REMARKS

DRAWINGS

AMENDMENTS TO THE DRAWINGS

The attached "Replacement Sheets" of drawings include changes to Figures 1, 2 and 4. The attached "Replacement Sheets 1/4, 2/4, and 4/4" which includes Figures 1, 2 and 4, replace the original sheets 1/4, 2/4 and 4/4 including Figures 1, 2 and 4.

Figure - 1

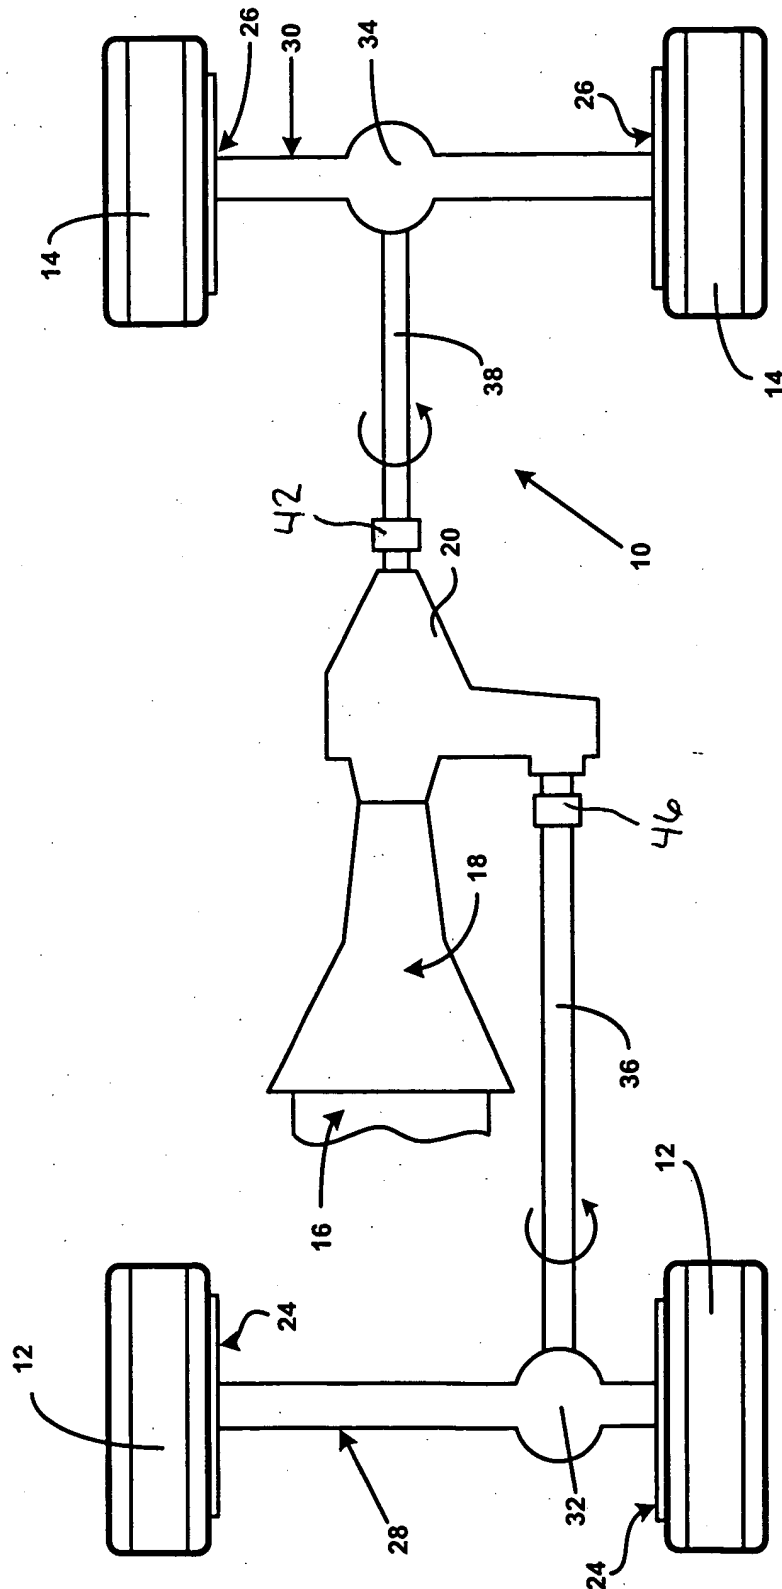
Applicants have attached revised drawings for the Examiner's approval. In the "Replacement Sheets", Figure 1 has been amended to add part numbers 42 and 46 to each of the rear coupling 42 and the front coupling 46 identified in paragraph [0014] of the specification.

2/4

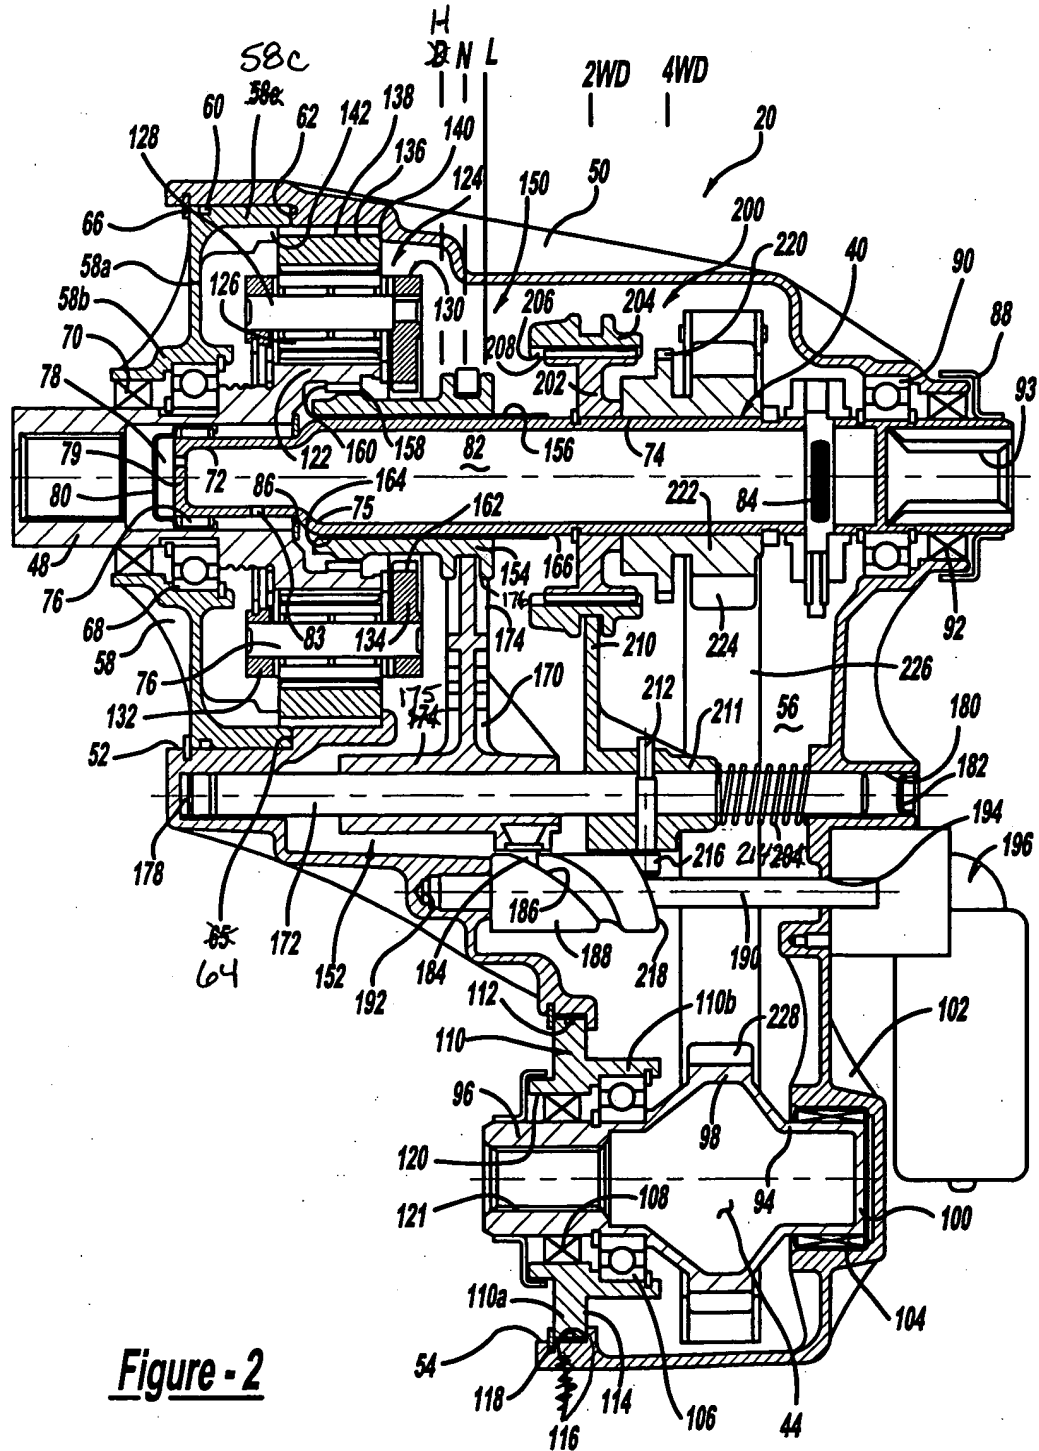
Figure 2 has been amended to change part number [58e] to 58c, the correct part number of the outer hub 58c identified in paragraph [0015] of the specification; to change part number [65] to part number 64, the correct part number for the radial shoulder 64 identified in paragraph [0015] of the specification; to change the letter [D] to H representing the "H" position line described in paragraph [0020] of the specification; to change part number [174] to 175, the correct part number for the tubular section 175 identified in paragraph [0021] of the specification; to add the numeral 176 in reference to peripheral groove 176 described in paragraph [0021] of the specification; and to correct part number [204] to part number 214 in reference to spring 214 described in paragraph [0022] of the specification.

Figure - 4

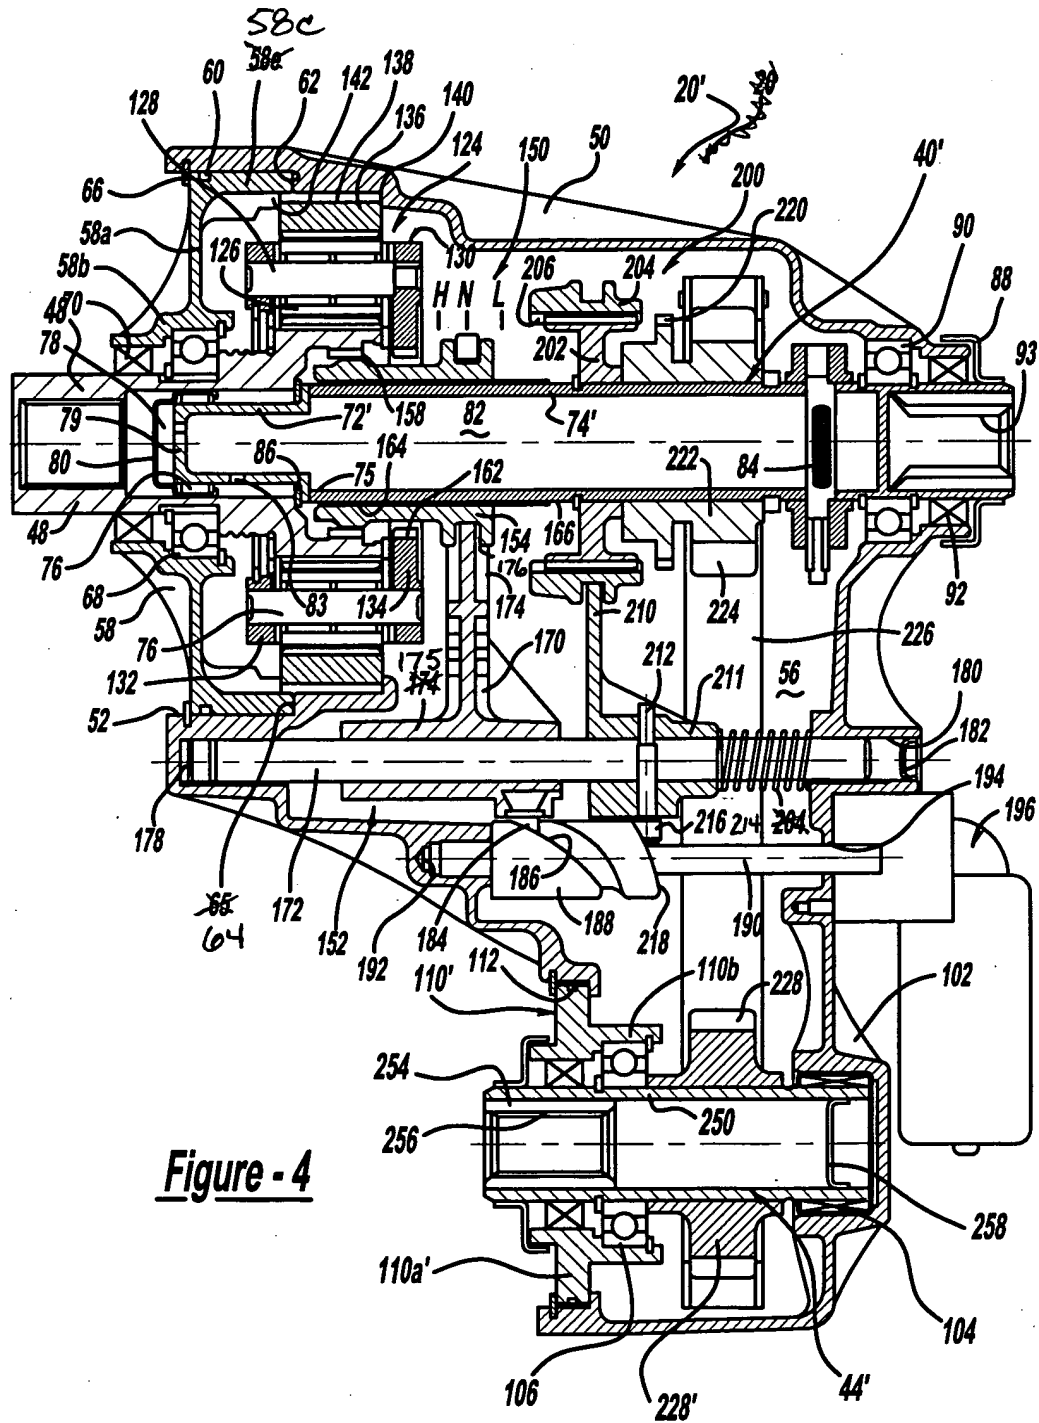
Figure 4 has been amended to incorporate the same changes made to Figure 2 for common incorrect or missing part numbers or letters. Figure 4 has been further amended to delete reference to numeral 20 and its reference arrow.
